HISTORIC AND DESIGN REVIEW COMMISSION

HDRC CASE NO: 2022-088
ADDRESS: 269 NORTH DR
LEGAL DESCRIPTION: NCB 6708 BLK 18 LOT 16- E 25 FEET OF 17
ZONING: R-6
CITY COUNCIL DIST.: 7
DISTRICT: Monticello Park Historic District
APPLICANT: Leonard C. McClure
OWNER: Leonard C. McClure
TYPE OF WORK: Modifications to the rear accessory structure
APPLICATION RECEIVED: January 20, 2022
60-DAY REVIEW: Not applicable due to City Council Emergency Orders
CASE MANAGER: Katie Totman

ADDENDUM TO APPLICATION FOR COA, GARAGE APARTMENT AT 269 NORTH DRIVE
REQUEST NO. 2022 23733

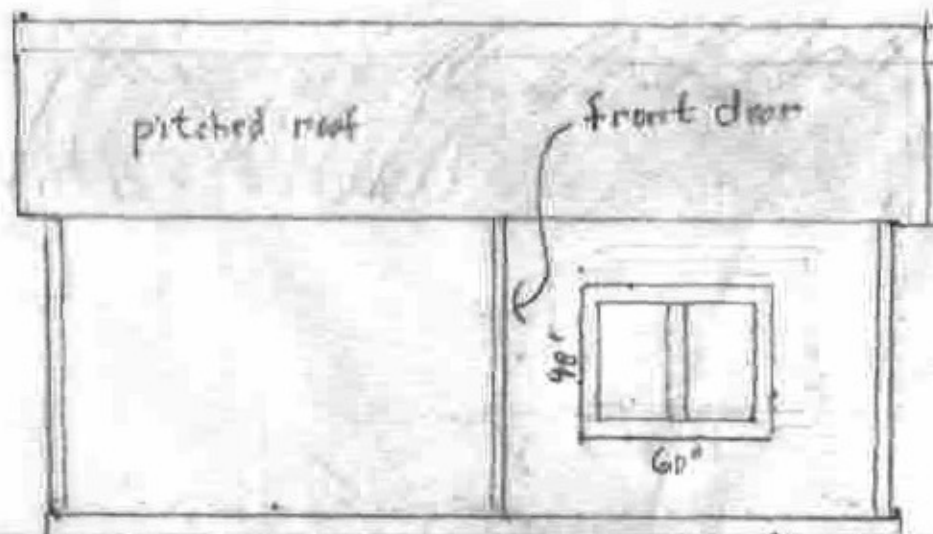
The existing door is 30X79. The new door will be enlarged to 32X80 to meet UDC requirements. It will be a white solid wood panel door. A screen door will be added, the same screen door that used to be on the house (see attached photo).

269 North Drive
Garage Apartment
(updated Jan. 13, 2022)

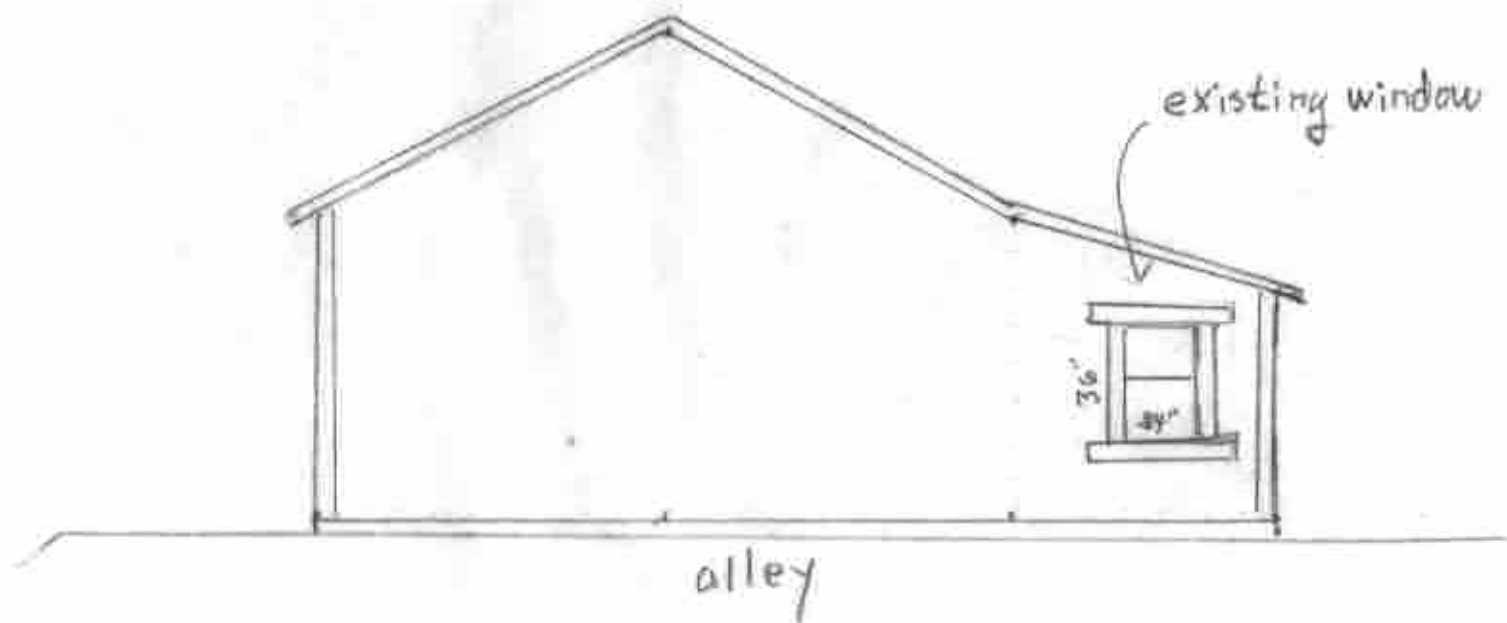
- b. **MODIFY THE GARAGE DOORS (SOUTH ELEVATION)** – The accessory structure currently features a double wide garage door with wood sliding doors. The applicant has proposed to remove the doors and enclose the area with siding and add two ganged wood windows (the windows will be covered by traditional wood screens). Although the Historic Design Guidelines for Exterior Maintenance and Alterations 9.A.i., notes to preserve existing outbuildings where they remain, staff finds that the use of trim around the area where the doors exist will visually preserve the historic appearance.

The only window in the proposed renovation that can be seen from the street is actually two 28X48 double hung windows with a 3.5" vertical trim in between, and the same trim continues on all sides. Made completely of wood, the design will conform to OHP's specific guidelines. (See updated drawing of south elevation.)

All siding and trim will be the same as in the original structure (horizontal planks 7.5" wide). As per Stephanie's recommendation, the frame of the garage door opening will remain in place (see updated drawing of south elevation). The entire exterior will be white, in keeping with the original garage.

Staff recommends approval of items 1-4 based on findings b through e with the following stipulations:

269 North Drive Garage Apartment (east ext. wall)

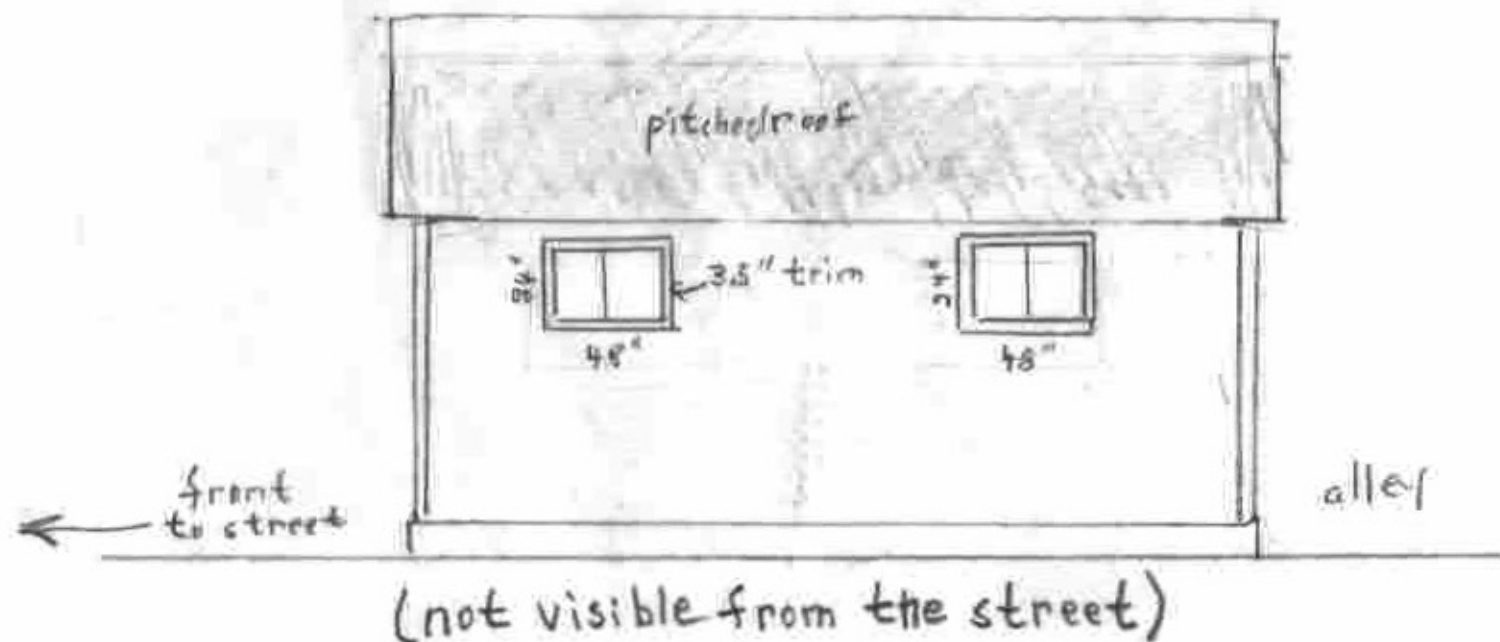
- c. **WINDOW INSTALLATION (EAST/WEST ELEVATION)** – The accessory structure does not feature windows on the east or west elevation and the applicant is proposing to install wood windows and aluminum sliding windows. The wood windows will be located on the west elevation and the aluminum sliding windows will be located on the east elevation, specifically toward the top of the façade to allow for ventilation and light. Staff finds that the proposed wood windows are consistent with the guidelines. The aluminum windows could be consistent with the guidelines, though no details have been submitted to staff at this time.

The two high windows on the east side are meant only for ventilation, and to let in some light in an otherwise dark interior. They are set high for security, as this is a hidden space near the alley, facing the neighbor's high wooden fence. They will be aluminum horizontal sliders with built-in screens. They are not visible from the street.

- i. That the windows on the east elevation be consistent with the standard stipulations as noted in the above references.

- ii. That final window product specifications be submitted to staff to review prior to the issuance of a COA.
